# Sections 104, 104A-D, 106, 108, 220 Resource Management Act 1991

Report pursuant to section 42A of the Resource Management Act 1991 recommending whether or not an application for resource consent should be:

**Resource Consent Number: 225715 & 225716**

<b>APPLICANT:</b>	Kevler Development Limited
<b>PROPOSAL:</b>	RC225715 – To undertake a staged subdivision (RC225715) creating 266 fee-simple residential allotments, roads and reserves in Rolleston RC225716 – To undertake earthworks, construct roading/access and establish residential dwellings
<b>LOCATION:</b>	Springston Rolleston Road, Rolleston
<b>LEGAL DESCRIPTION:</b>	Lot 2 DP 61162 being 15.9235ha in area more or less, as contained in Record of Title CB38C/605.
<b>ZONING:</b>	<b>Operative Selwyn District Plan (2016)</b> The property is zoned Inner Plains under the provisions of the Operative District Plan (Rural) Volume
<b>STATUS:</b>	<b>Operative Selwyn District Plan (2016)</b> RC225715 has been assessed as a subdivision consent for a Non-Complying activity under the Operative District Plan. RC225716 has been assessed as a land use consent for a Non-Complying activity under the Operative District Plan.

Figure 1: Proposed subdivision layout, with key differences to the proposed ODP shown

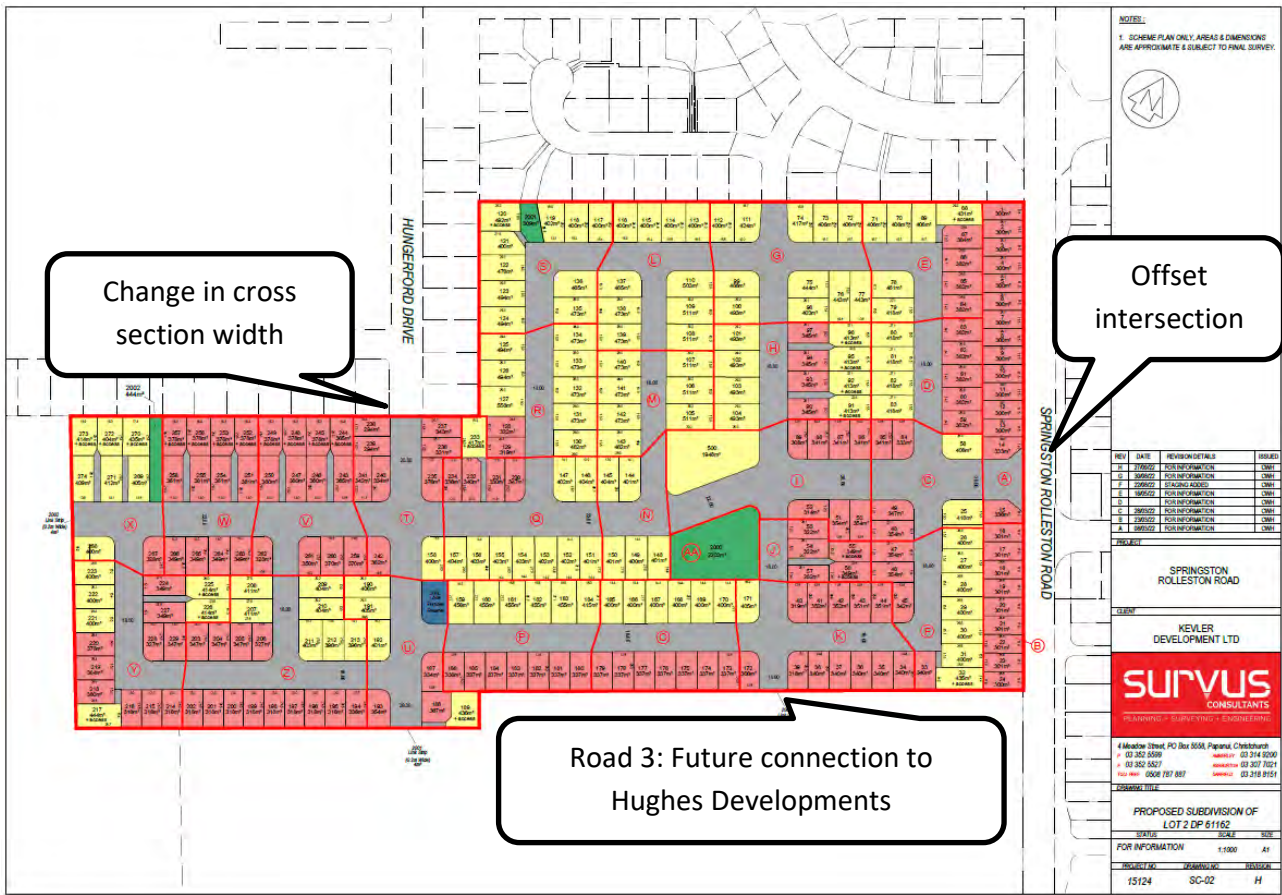
The applicant has proposed the roading layout shown in Figure 1. As part of the FUDA PC, an Outline Development Plan (ODP) is proposed, which is shown in Figure 2 (with the Site shown as “Site 4”). Key differences include (shown in Figure 1):

Figure 3: Additional cycle facilities recommended by Flow

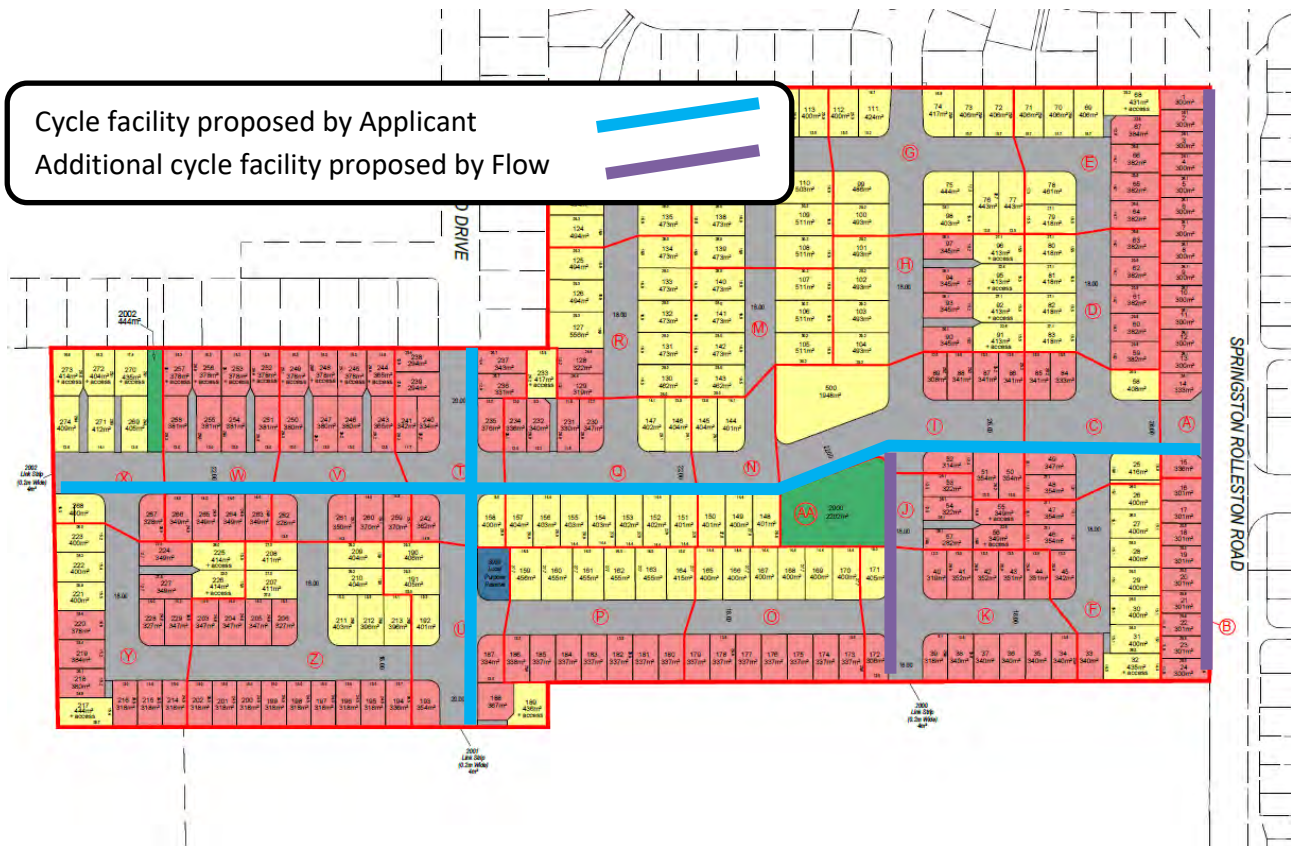
***Outcome: We recommend that a shared use path is provided on***

- ♦ ***Road 3, south of Road 1, as this link is identified as a cycling route in the FUDA PC ODP***
- ♦ ***Springston Rolleston Road, which is consistent with frontage upgrades delivered by other recent residential developments fronting arterial roads in Rolleston.***
